DATE: August 4, 2011

SUBJECT: Addendum No. 2
El Dorado Trail Culvert Replacement Project
(Contract No. PW 11-30587, Project No. 99565)

PROJECT PLANS FOR THE CONSTRUCTION OF EL DORADO TRAIL CULVERT REPLACEMENT

SHEET
L-1R
 2 OF 10
 W.O. No. **99565**

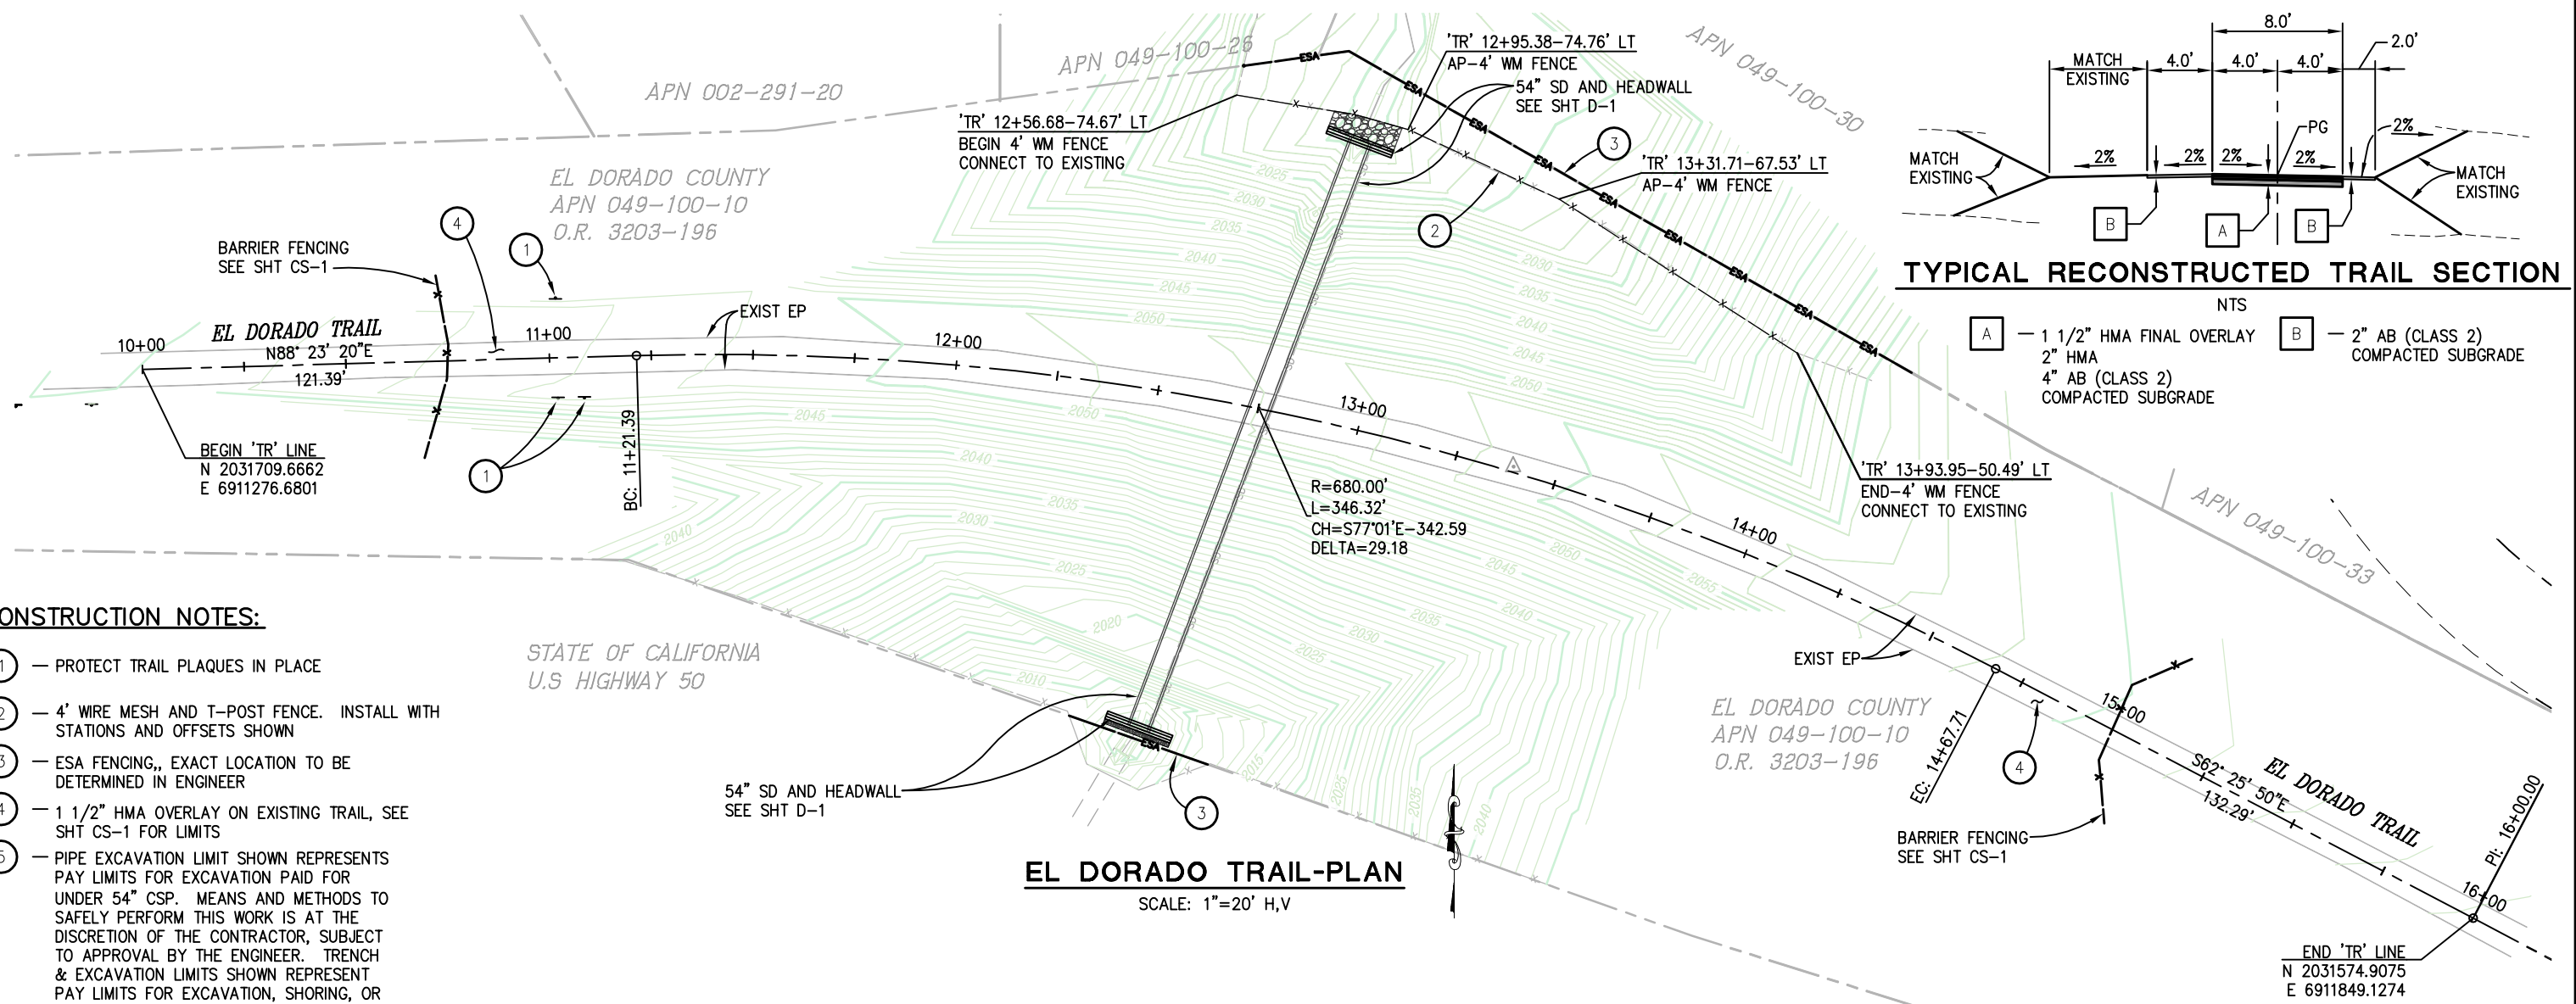
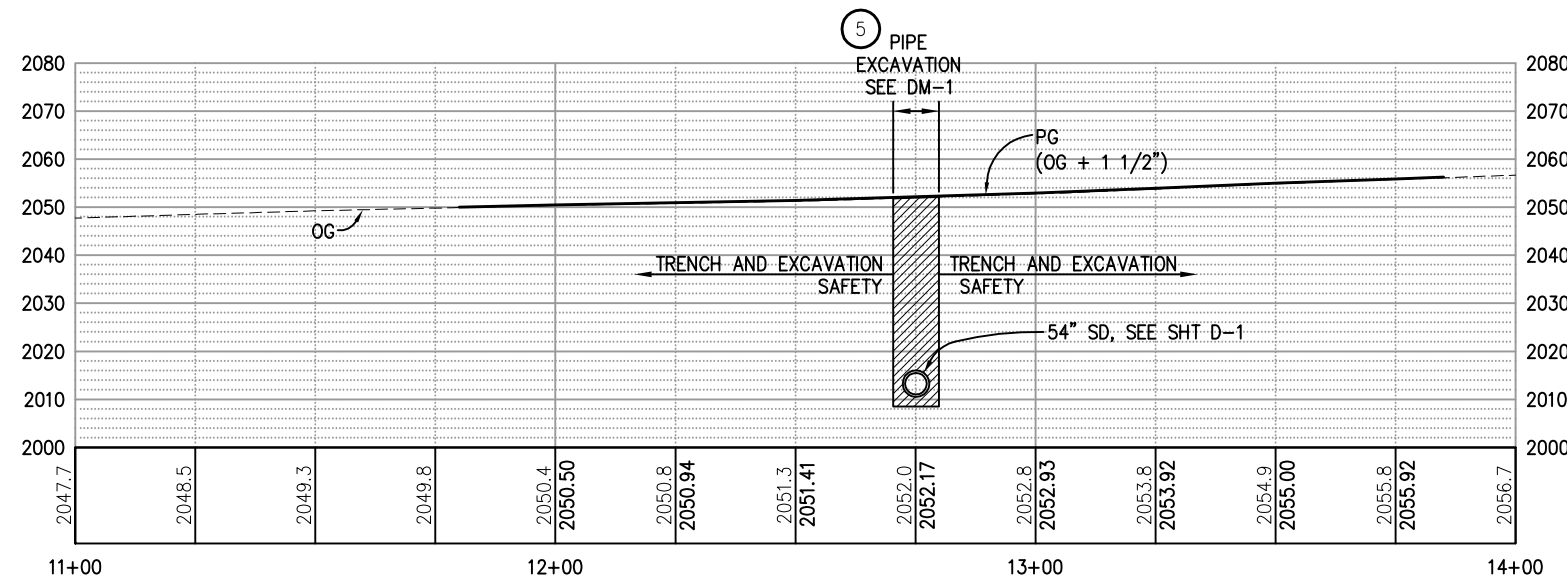
ITEM NO.	LOCATION, PAGE OR DRAWING NO.	DESCRIPTION OF CHANGE
2.01	Plan Sheets 1 through 10	Revisions to the existing ground and design elevations have been made on the plans to address the error found in the topographic survey. Revised Plan Sheet D-1 (3 of 10) issued with Addendum No. 1 has also been revised to show a single concrete cut off wall. Revised Plan Sheet CS-1 (5 of 10) issued with Addendum No. 1 has no further revisions, but has been attached to this addendum. Bidders are instructed to replace original Plan Sheets 1, 2, 4, 6, 7, 8, and 9 of 10 and revised Plan Sheets 3 and 5 of 10 (issued with Addendum No. 1) with the revised Plan Sheets 1 of 10 through 10 of 10 attached to this Addendum No. 2.

REVISION	NUMBER	DATE	DESCRIPTION	BY
2	08/01/11		REVISIONS TO EXISTING GROUND AND DESIGN ELEVATIONS	SGM

SHEET
D-1R
3 OF 10
W.O. No. **99565**

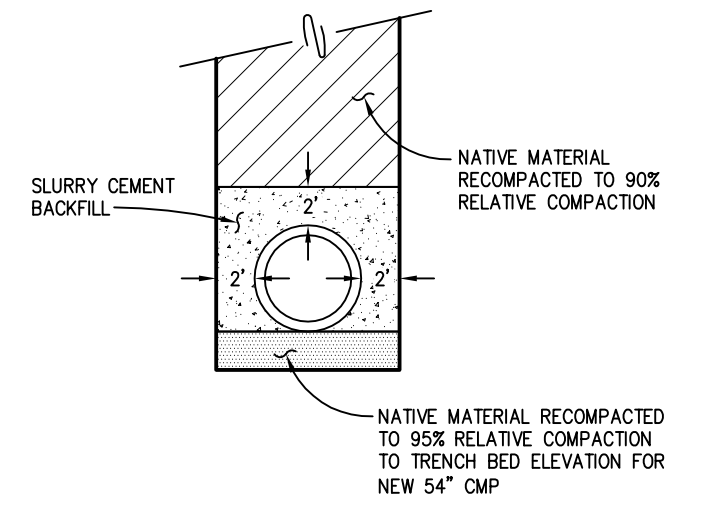
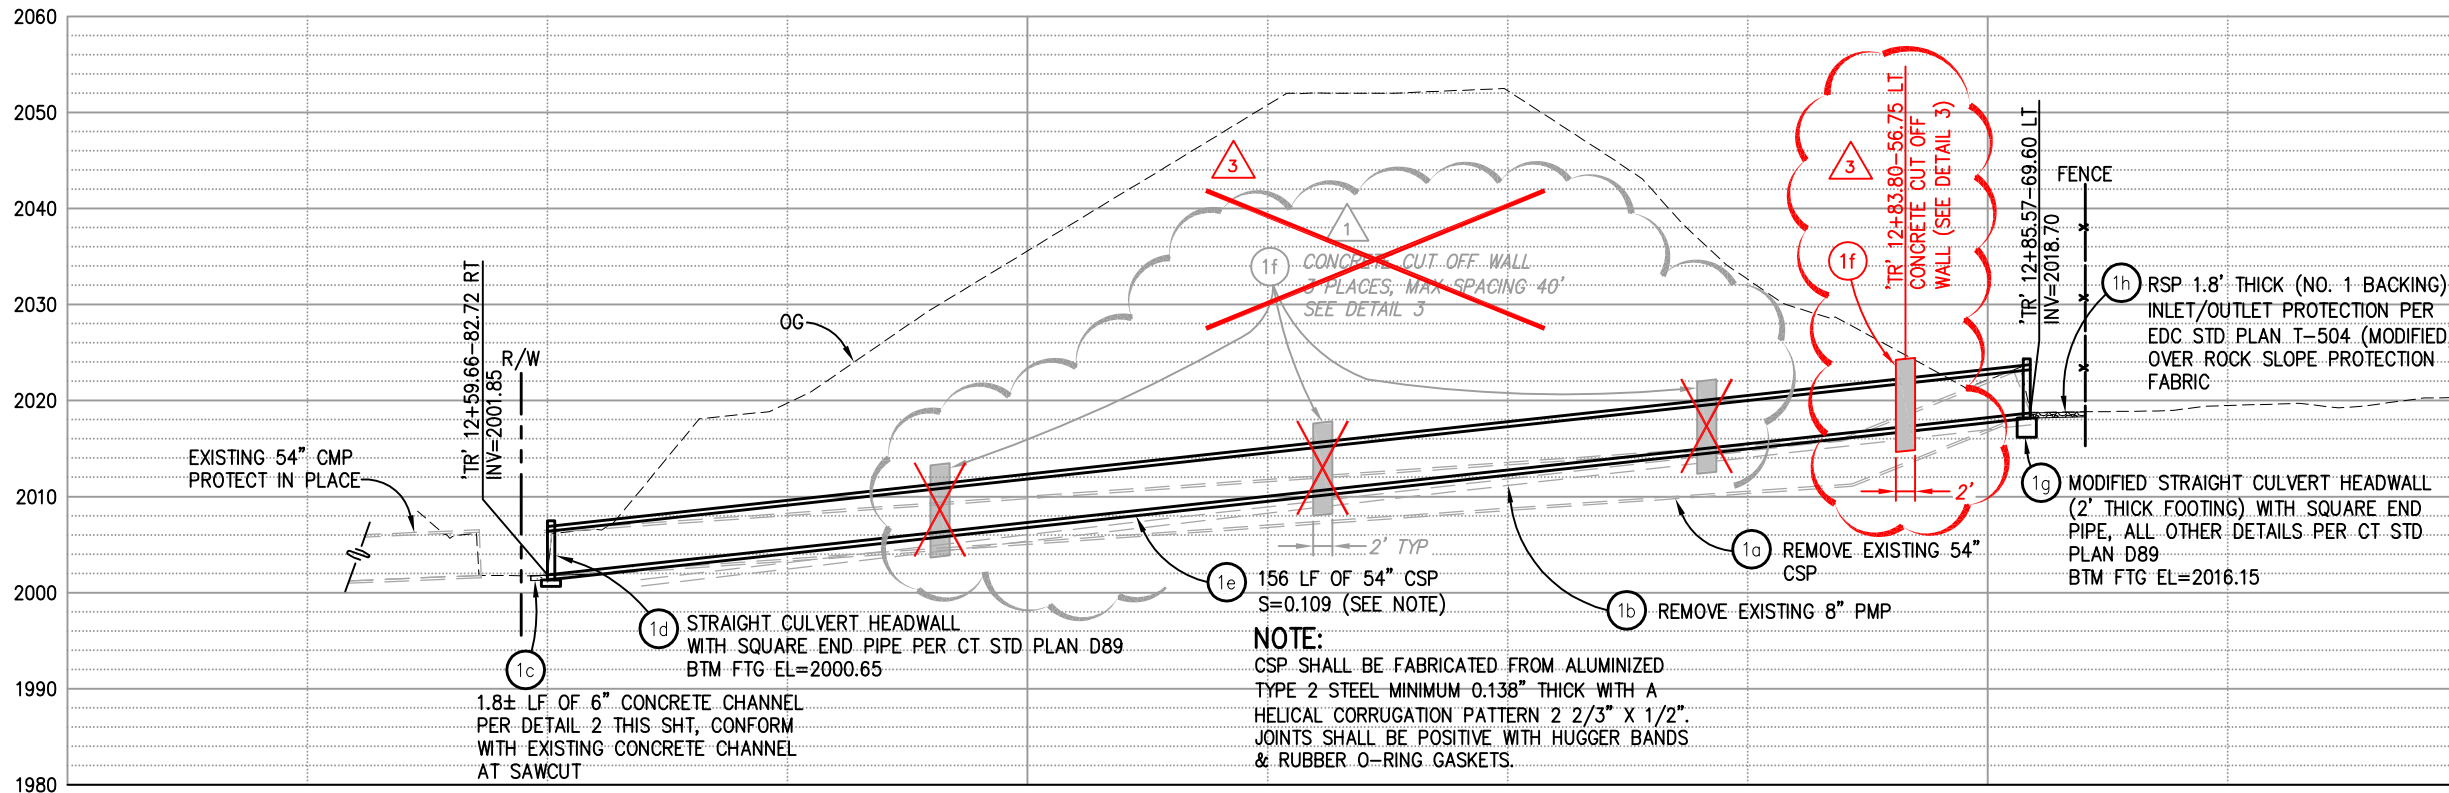
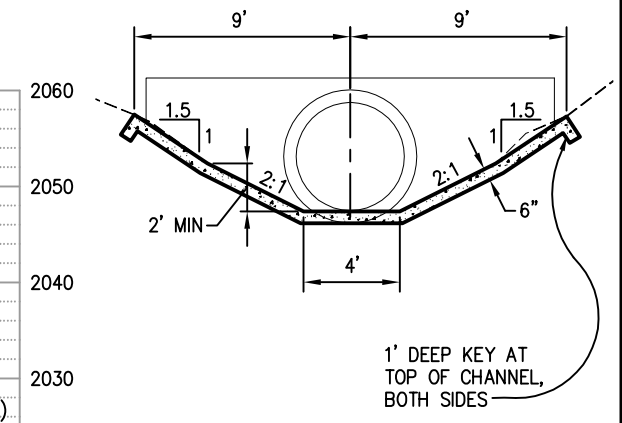
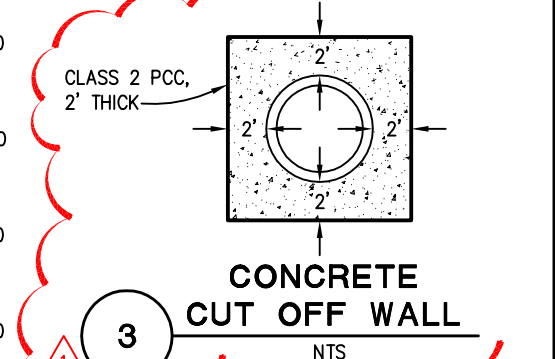
<i>capable of passing stream flows, within 25 working days after the notice to proceed is issued.</i>
2.04	Item 1.04 of Addendum No.1	Change “ <i>concrete cut off walls</i> ” to “ <i>concrete cut off wall.</i> ”
2.05	Item 1.08 of Addendum No. 1 Pages C-9rev and P-3rev	Replace Page C-9rev of Exhibit A Contractor’s Bid and Bid Price Schedule issued with Addendum No. 1 with Page C-9rev 2 attached to this Addendum No. 2. Replace Page P-3rev of the Proposal Pay items and Bid Price Schedule issued with Addendum No. 1 with Page P-3rev 2 attached to this Addendum No. 2.
